Integrated Device Technology, Inc.  
2975 Stender Way, Santa Clara, CA - 95054

## PRODUCT/PROCESS CHANGE NOTICE (PCN)

PCN #: **A-0412-04**                      DATE: 12/15/2004

Product Affected: All Green Products

#### Before Change (example)

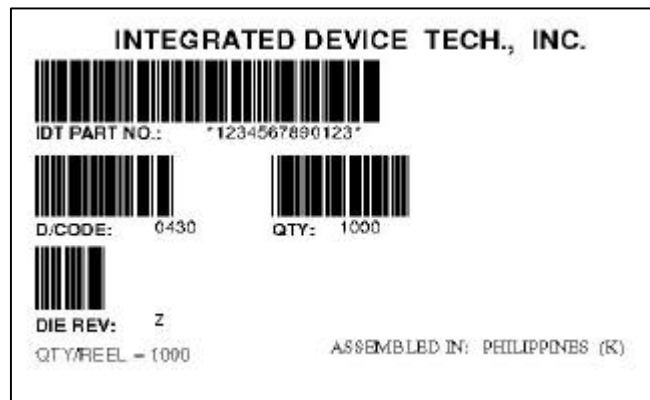
Add Pb-free words, category and maximum safe operating temperature to IDT standard bar code label.

#### After Change (example)

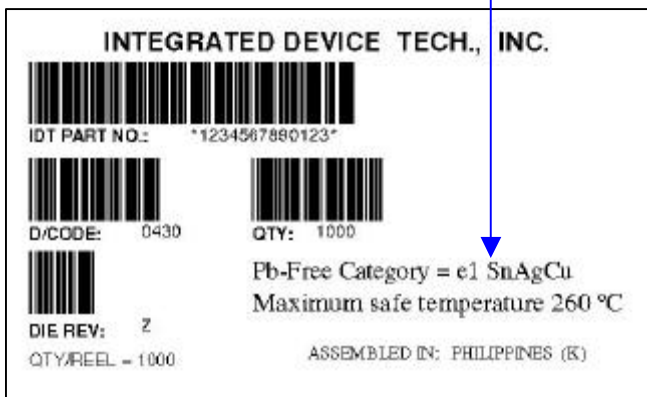
Pb-free category = e1 SnAgCu (BGA packages)  
and maximum safe temperature

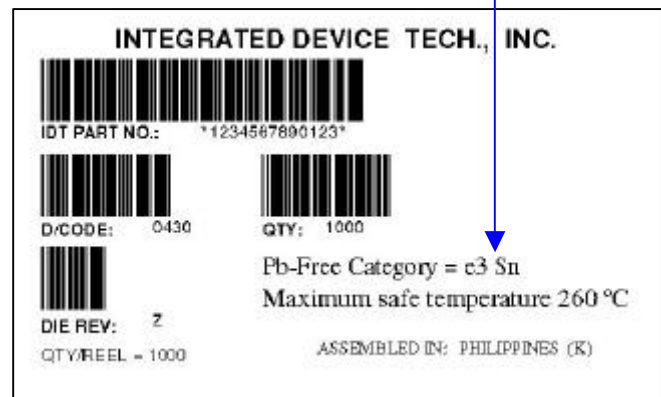
Pb-free category = e3 Sn (lead frame packages)  
and maximum safe temperature

#### Attachment 2: (Customer specific)

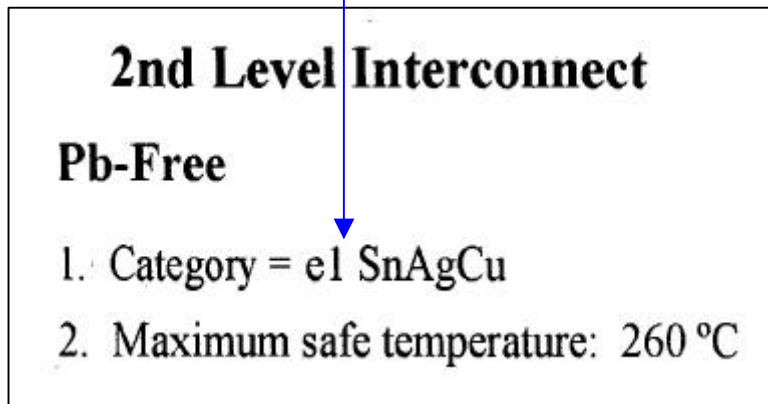
Add an additional 2nd Level Interconnect label consisting of Pb-free words, category and maximum safe operating temperature.

Category = e1 SnAgCu (BGA packages)

Category = e3 Sn (lead frame packages)
